80ETEC-DRF-4220

Subject: Midland Plant Units 1 & 2: Bending Stresses in Underground Piping Due to Differential Soil Settlement

REINFORCING STRESSES IN UNDERGROUND PIPING DUE TO DIFFERENTIAL SOIL SETTLEMENT - MIDLAND PLANT UNITS 1&amp;2

FIG 19.1 Ref 1

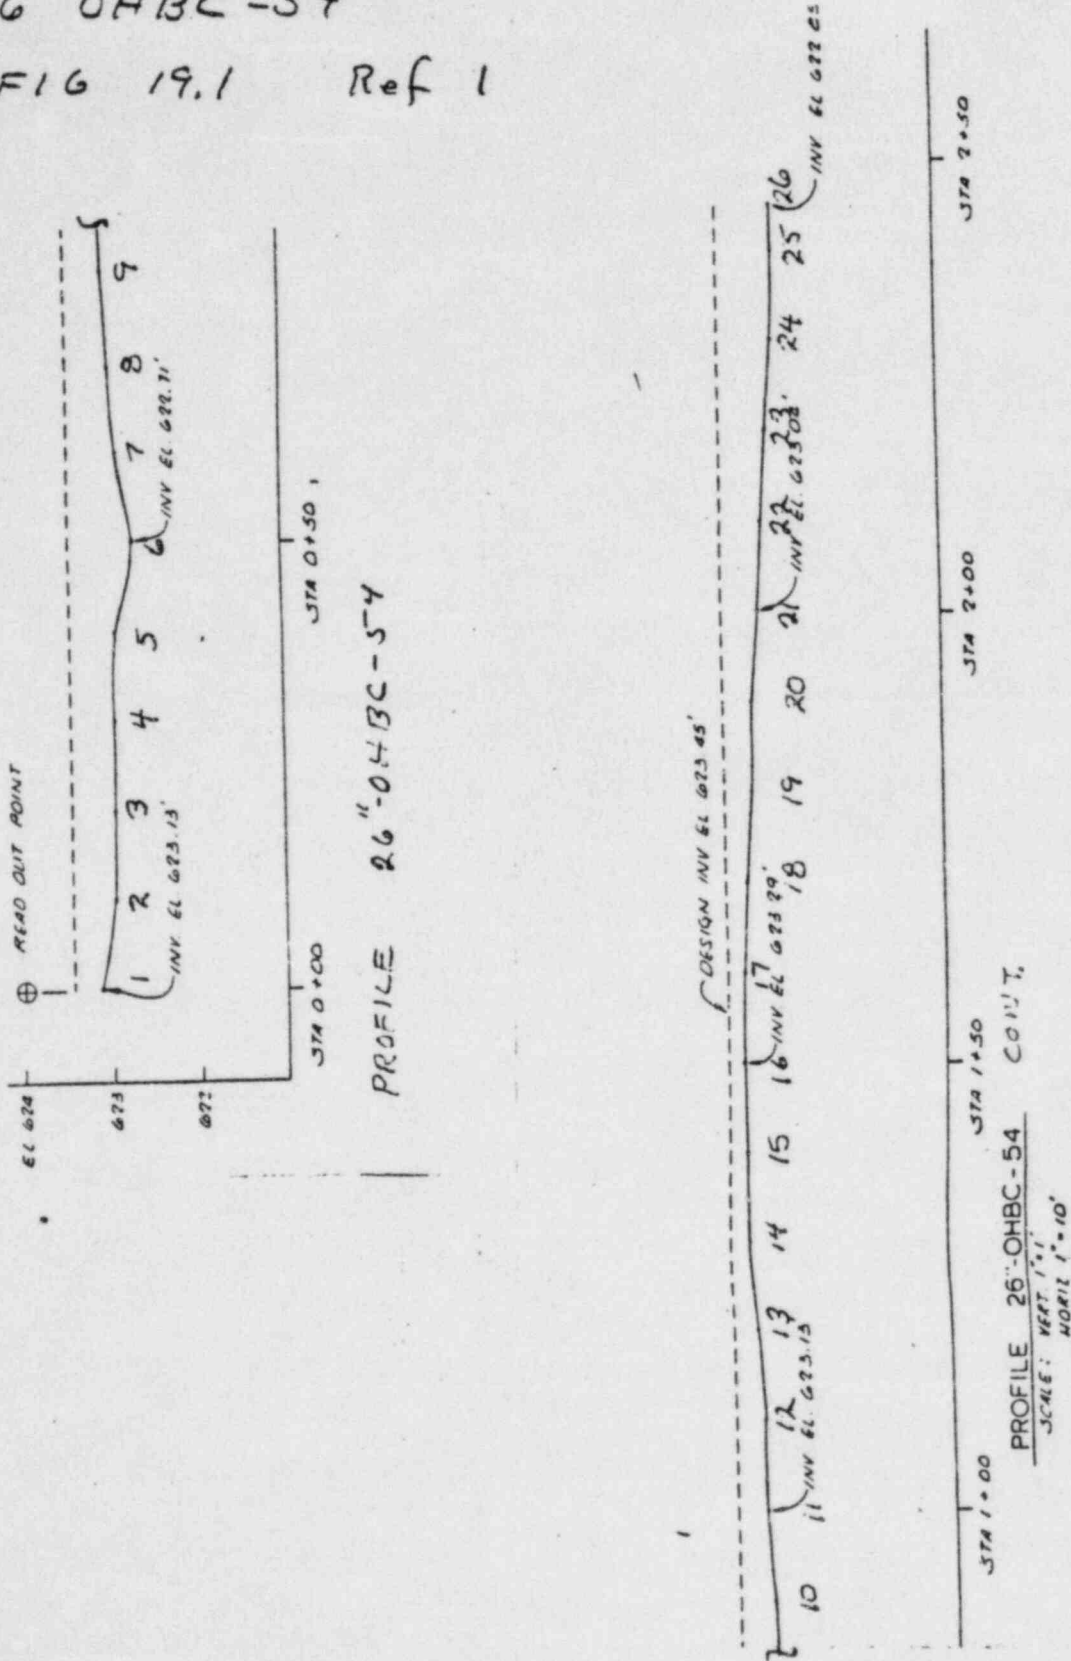
THE PROFILES OF SEVERAL OF THE LINES OF FIGURES 17.2 AND 19.1 OF REF. 1 WERE ANALYSED BY AN ETEC IN HOUSE COMPUTER PROGRAM IN AN ATTEMPT TO VERIFY THE MAXIMUM STRESSES FOR THESE LINES PER REF. 1. THE MAXIMUM STRESSES OBTAINED FROM THIS ANALYSIS WERE CONSIDERABLY HIGHER THAN THOSE OF REF. 1. HAND CALCULATIONS WERE ALSO MADE AS AN ADDITIONAL CHECK, WITH THE RESULTS BEING SIMILAR TO THOSE OF THE COMPUTER ANALYSIS.

- 1) THE DEFLECTIONS OF THE PIPES AS OBTAINED FROM THE PROFILES OF FIGURES 17.2 AND 19.1 WERE INPUT INTO THE PROGRAM AT THE NODAL POINTS SHOWN ON THE NODAL MAPS ENCLOSED WITH THE COMPUTER PRINTOUT.
- 2) TWO CASES WERE RUN FOR EACH LINE. CASE 1 ASSUMED THE ENDS OF THE LINES WERE COMPLETELY FIXED. CASE 2 ASSUMED THE ENDS OF THE LINES HAD NO MOMENT CARRYING CAPABILITY.
- 3) WALL THICKNESSES OF STANDARD PIPE WERE USED IN THE ANALYSIS. AS THE ACTUAL WALL THICKNESSES WERE NOT KNOWN, THIS WOULD NOT AFFECT THE STRESSES AS THEY ARE

SIMPLE HAND CALCULATIONS WERE MADE TO VERIFY THE COMPUTER ANALYSIS FOR THE SECTION OF LINE 26" OHBC-57 IN THE AREA OF THE DIP BETWEEN NODES 5 AND 7

- 5) THE METHOD GIVEN IN RESPONSE TO QUESTION 19 OF REF 1 IS AT BEST A ROUGH APPROXIMATION, BUT EVEN THIS METHOD GIVES VERY HIGH BENDING STRESSES FOR THE AREA BETWEEN NODES 5 & 7

Figure 19-1 of your response to Question 19 in "Responses to NRC Requests Regarding Plant Fill" regarding piping founded in the plant area fill shows some differences between profiles of a given pipe taken on different dates. Specifically, the profile for pipeline 10" - OHBC-27 taken September 1979 is at a higher elevation than the profile of that same line taken in January 1979. How do you reconcile these differences?

Figure 19-1 of your response to Question 19 in "Responses to NRC Requests Regarding Plant Fill" regarding piping founded in the plant area fill shows some differences between profiles of a given pipe as taken on different dates. Specifically, the profile for pipeline 8" - 1HBC-81 measured in September 1979 is at a deeper elevation than the profile of this pipeline taken in January 1979 and the change in slope for the September 1979 profile is not as great as for the January 1979 profile. How do you reconcile this behavior?
